CAC Meeting #4 Design Workshop Summary Report

Barbara Hall Park Vision and Improvement Plan
Phase 2: Exploring Design Options

City of Toronto – Parks and Recreation
September 23, 2025

Figure 1: Group 1 chart paper, World Café round one

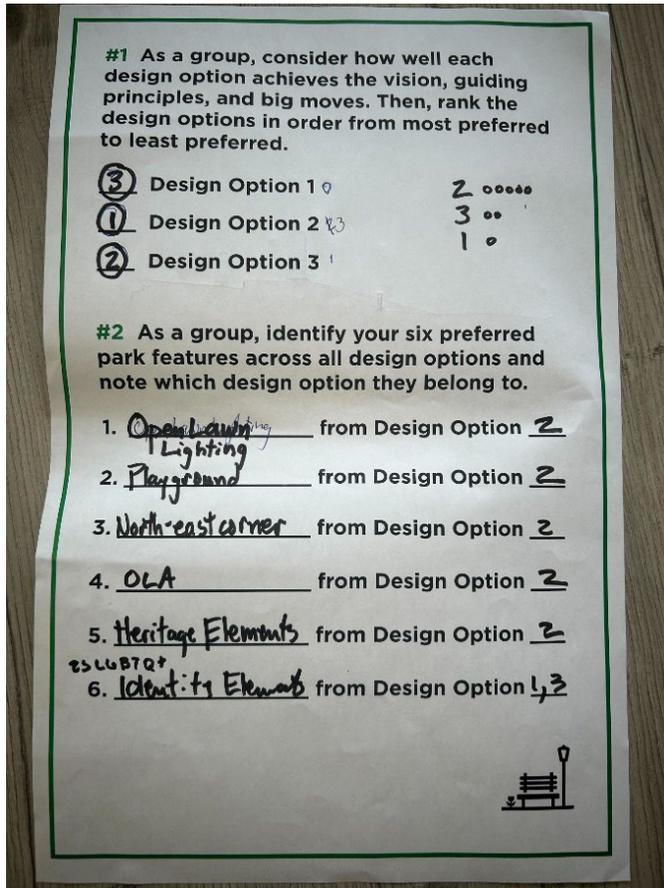
- Rank 1st: Design Option 2
- Rank 2nd: Design Option 3
- Rank 3rd: Design Option 1

- 1: Open lawn lighting from Design Option 2

- 2: Playground from Design Option 2
- 3: Northeast corner from Design Option 2
- 4: OLA from Design Option 2
- 5: Heritage Elements from Design Option 2
- 6: 2SLGBTQ+ Identity Elements from Design Option 1 and 3

Figure 2: Group 2 chart paper, World Café round one

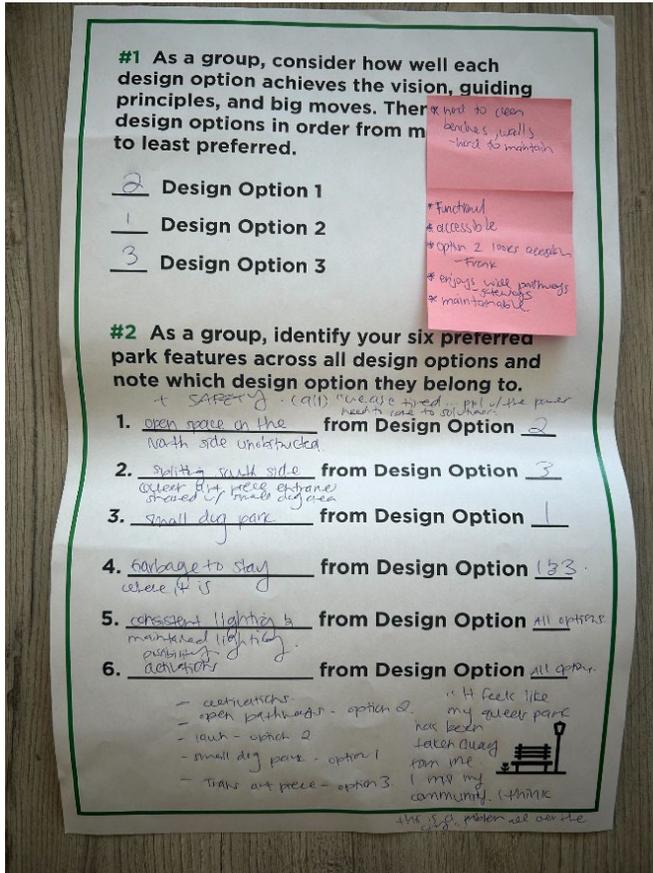
- Rank 1st: Design Option 2
- Rank 2nd: Design Option 1
- Rank 3rd: Design Option 3

- 1: Open Space from Design Option 2
- 2: Splitting South Side from Design Option 3
- 3: Small Dog Park from Design Option 1
- 4: Garbage to say from Design Option 3
- 5: Consistent lighting from Design Option (All Options)
- 6: Activations from Design Option (All Options)

Figure 3: Group 3 chart paper, World Café round one

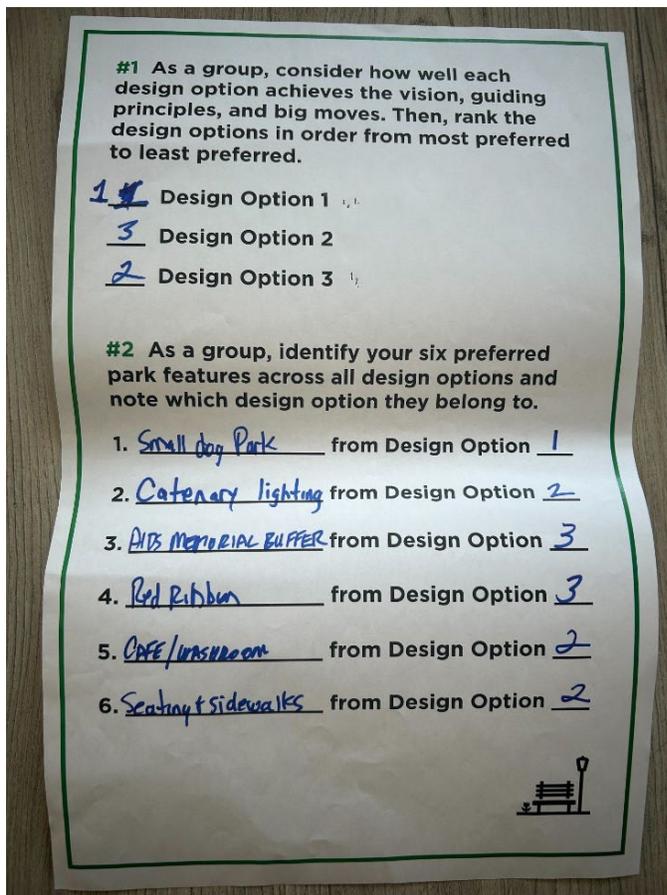
- Rank 1st: Design Option 1
- Rank 2nd: Design Option 3
- Rank 3rd: Design Option 2

- 1: Small Dog Park from Design Option 1
- 2: Catenary Lighting from Design Option 2
- 3: AIDS Memorial buffer from Design Option 3
- 4: Red Ribbon from Design Option 3
- 5: Café/Washroom from Design Option 2
- 6: Seating and Sidewalks from Design Option 2

Figure 4: Group 1 chart paper, World Café round two

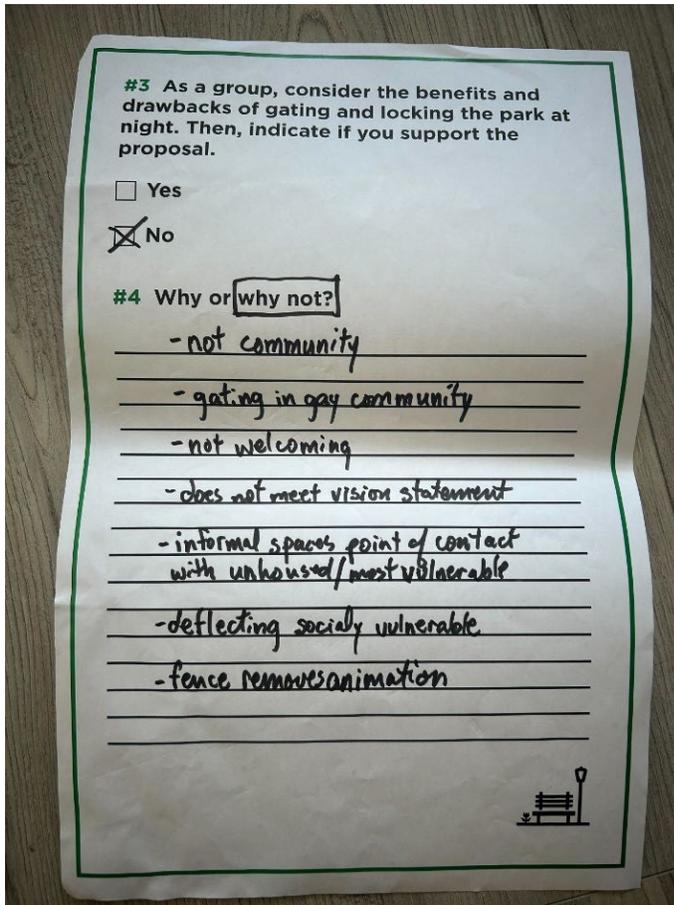
- Yes: ()
- No: (X) – “No” was selected

- Not community
- Gating in gay community

- Not welcoming
- Does not meet vision statement
- Informal spaces point of contact with unhoused/most vulnerable
- Deflecting socially vulnerable
- Fence removes animation

Figure 5: Group 2 chart paper, World Café round two
Question 3: As a group, consider the benefits and drawbacks of gating and locking the park at night. Then, indicate if you support the proposal:

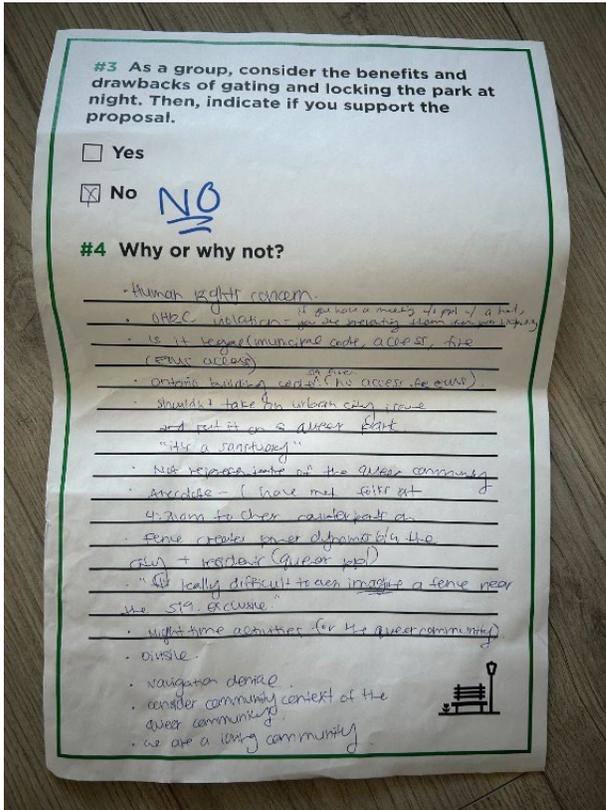
- Yes: ()
- No: (X) – “No” was selected

- Human Rights concern
- OHRC violation
- Is it legal
- Shouldn't take an urban city issue and put it on a queer park. “it's a sanctuary”
- Not representative of the queer community

- Fence creates power dynamic

Figure 6: Group 3 chart paper, World Café round two
Question 3: As a group, consider the benefits and drawbacks of gating and locking the park at night. Then, indicate if you support the proposal:

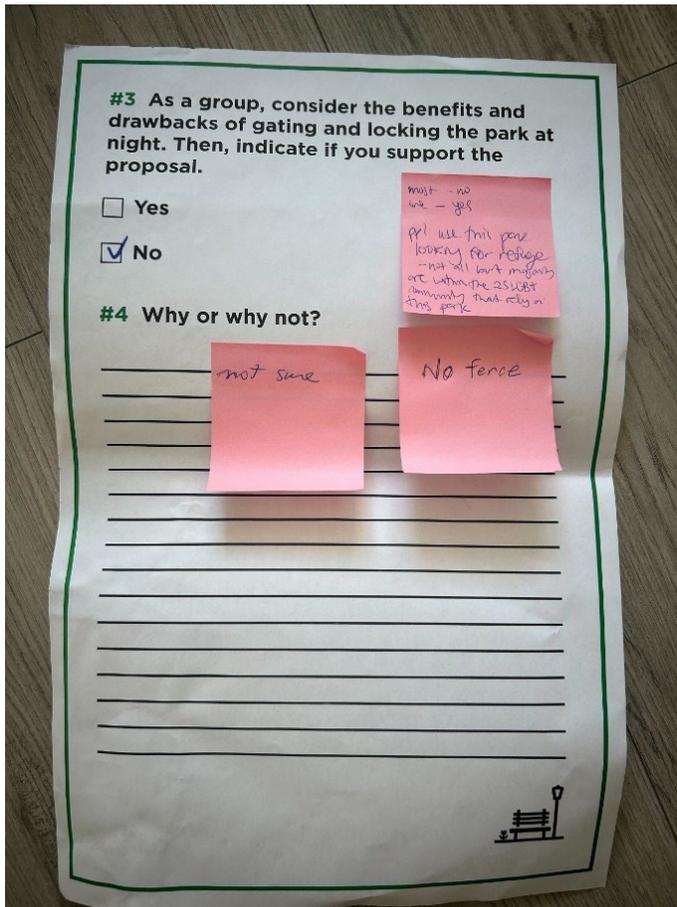
- Yes: ()
- No: (X) – “No” was selected

- People use this park looking for refuge
 - Not all but majority are within the 2SLGBTQ+ community that rely on this park
- No Fence
- Not Sure
